DEPARTMENT OF TRANSPORTATION FEDERAL AVIATION ADMINISTRATION SPECIFICATION

LOADBANKS, 30KW AND 50KW, 3 PHASE, 208/240 VOLTS

This amendment shall be made part of FAA-1365b dated September 18, 1968.

FIGURE 1

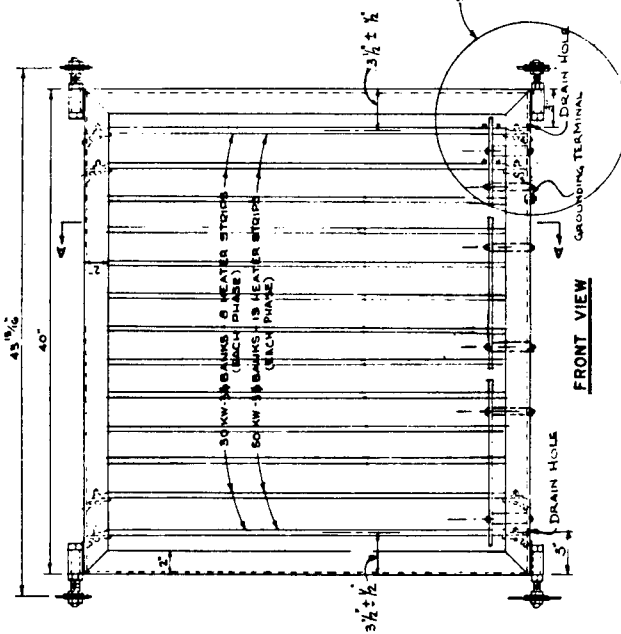
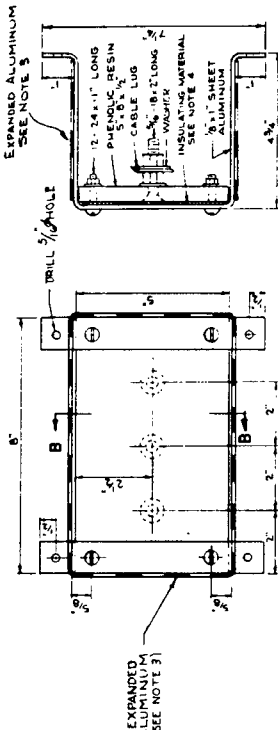
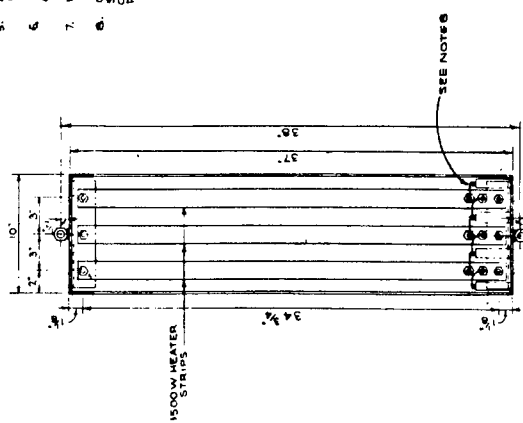
Page 9, Figure 1: Delete that portion of Figure 1 entitled "WIRING DIAGRAM (30 KW)".

Page 9, Figure 1: FRONT VIEW - Change the drawing of the bus bar and bus bar supports to show the bus bar split into three sections as indicated in Figure 2 of this amendment and to show each section of bus bar supported by two insulated supports.

FIGURE 2

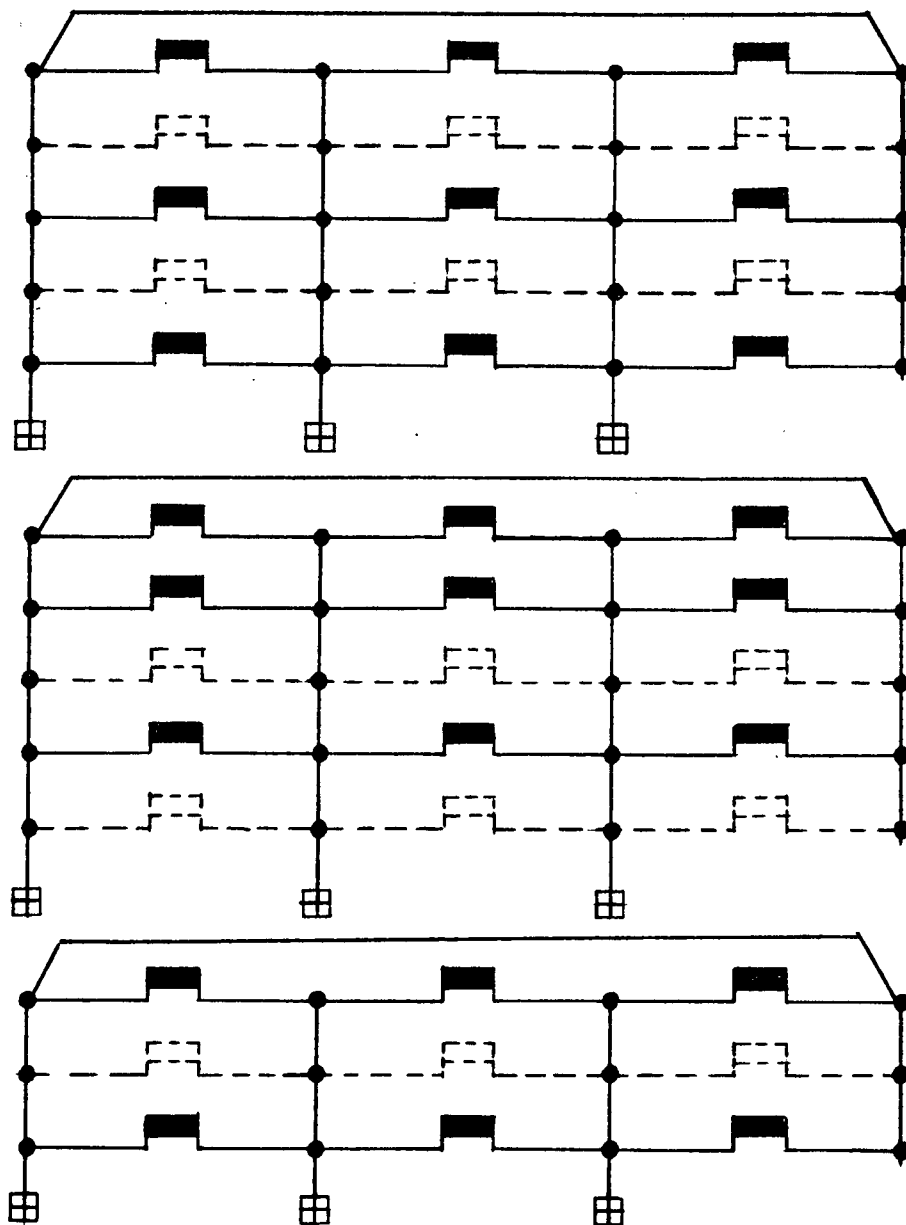
"They shall be mounted in the aluminum frame in three banks, each delta connected as indicated in Figure 2, and consist of a total of 8 heater strips per phase for the 30KW units and 13 heater strips per phase for the 50KW units. The heater strips shall be distributed between the three banks as indicated in Figure 2."

"The heater strip units of both the 30KW and the 50KW load banks shall be connected to twelve 5/16" bus bars arranged in four rows as shown in Figure 2. One end of each of three buses in each of the three load sections shall be turned down and threaded 5/16 inch-24. Each bus bar shall be supported by two insulated supports."

Page 10: Insert Figure 2 of this amendment.
